Date: July 13, 2021

RE: Village Hall and Site Construction, EN2104 & EN2105– Request for information

Thank you for your interest in the Village’s project. Highlighted responses to requests for information are listed below. Please note the list is a compilation of questions submitted from multiple Contractors and Suppliers.

Village Hall of Royal Palm Beach - 6' Diameter Circle

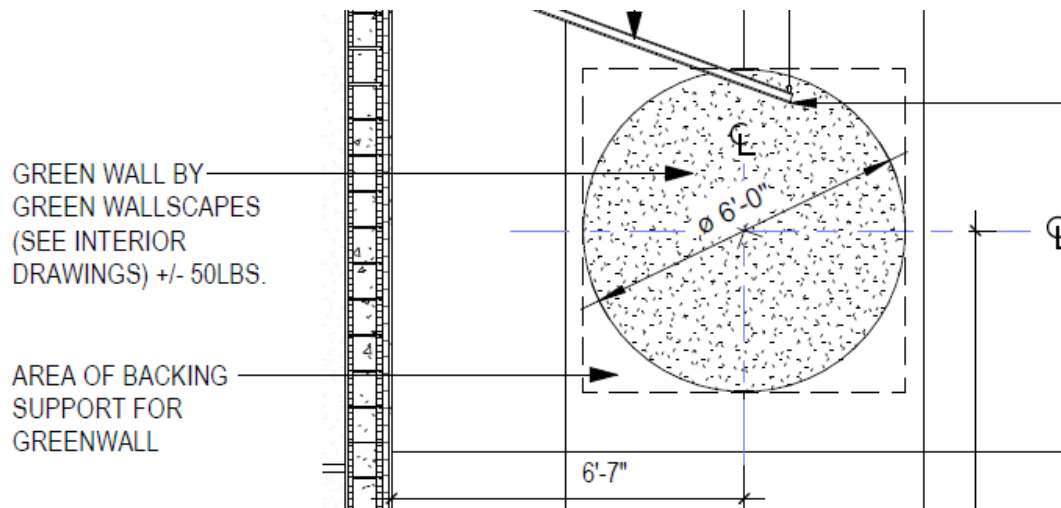
Q. Can you tell me where to find additional/detailed info on the Green Wall, details of the circled area in drawing A-4.50? it is the one with the section: 4 Main Lobby (127) Elevation 3

As stated in the drawings, the green wall feature is provided by Green Wallscapes. These items are all custom made by the company for the customer as an "art" piece. Our Interior Designer contacted the company and obtained the below quote for informational purposes. It is a 6'-0" diameter preserved moss and fern, circled-shape installation. The attached document does not constitute the final price for the item, it was obtained for informational purposes. The final piece may vary slightly in appearance from that shown in the attached picture. Bidders must contact Green Wallscapes (contact information attached in quote) for additional information regarding delivery and installation of item. Drawings call for backing behind wall in this location as we were informed that the piece can weigh up to 50 lbs. no addendum
